**Submission on Proposed Plan Change 7 – Rotokauri North Private Plan Change**

## Proposed Plan Change 7 Submission

Figure 15 -7a

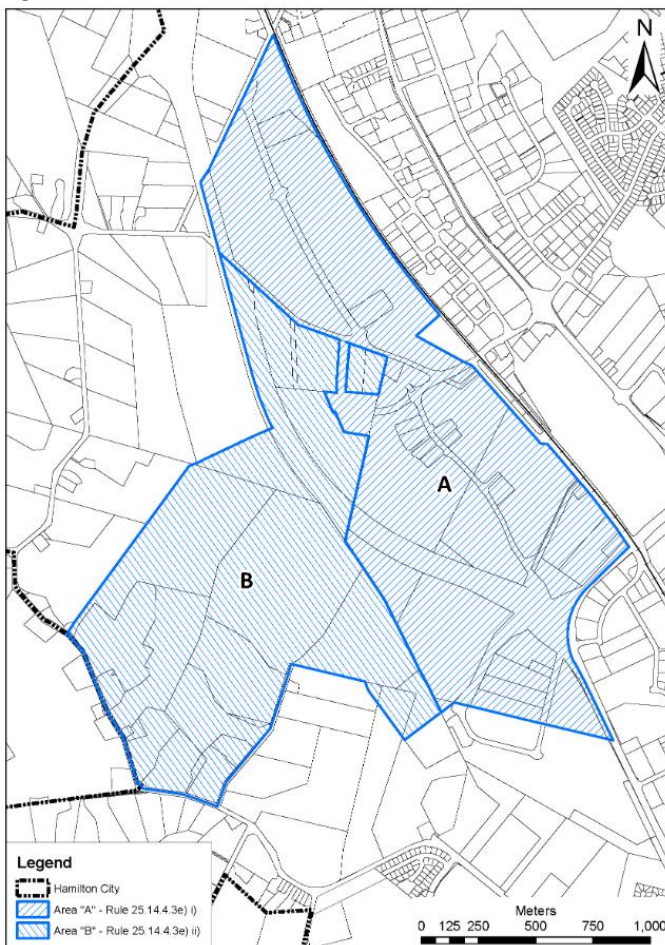
The proposed plan change is inconsistent with structure plan component *“3.6.3.2 Roding”* in its entirety. The proposed area is within the stage 2 area, outside of Areas A and B (see Figure 15-7a). The Rotokauri Structure Plan indicates that the release of land beyond stage 1A (such as the PPC): *“will be contingent upon the availability of network capacity which may arise as a result of traffic generation”* and 3.6.2.3 d and e) provide that:

*Proposals for the development of land in ‘Area B’ on Figure 15-7a will require careful scrutiny to ensure that adequate network capacity exists to support the development, or will be provided as part of the development and they will not compromise the development of land in ‘Area A’ on Figure 15-7a. Development will require:*

The PPC is clearly contrary to these provisions, and the developer is trying to dodge the full cost of developing ahead of the planned sequencing by exempting itself from these Rotokauri Structure Plan provisions. The PPC does not provide adequate transport network capacity outside of the PPC area to support the proposed development. The proposal does not achieve a sustainable expansion of the city and does not represent coherent and integrated development, because the transportation effects beyond the Rotokauri North boundaries have not been resolved.

- Decline proposed inclusion of section 3.6 d (exemption of PPC area from Rotokauri Structure Plan), but approve the development subject to requiring the developer to adhere to all existing Rotokauri structure Plan provisions, including:
  - a) requiring they construct the Rotokauri Minor Arterial Road;
  - b) provide an ITA that adequately assesses impacts on the wider transport network and have that ITA peer reviewed.
  - c) cater for the demand generated within the wider transport network;
  - d) requiring the developer to fund all necessary road network upgrades and additions.
  - e) provide a full economic assessment of the financial impact on the remainder of the Rotokauri Structure plan area and including the likely cost of the required roading upgrades.
